## 30' Chain Catch (Revision B) Page 1 of 2

## Assembly Update AU038

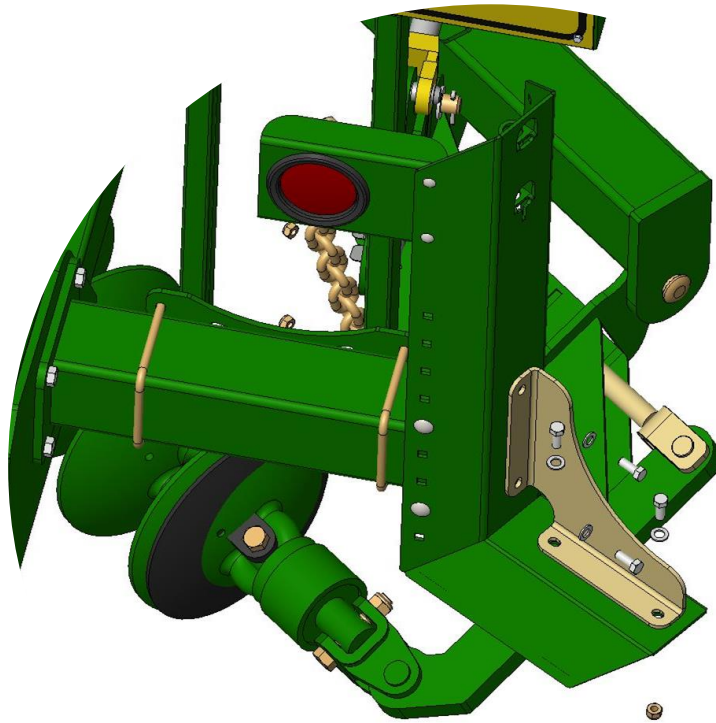
It has come to our attention that in some circumstances the right hand rear chain on the 30' machine has come off of the chain carrier end while in transport. To minimize this we have put a chain catch in place to resolve this issue. Please note that all chain carriers will have holes in them but it is only the rear two that need the catch.

New kit will include,

2x0800-360 plate

8xM12x8.8x30mm ZP Bolts (0211-1230)

8xM12 Flat washers (0231-F12)

8xM12 Nyloc Nuts (0221-NYL12)
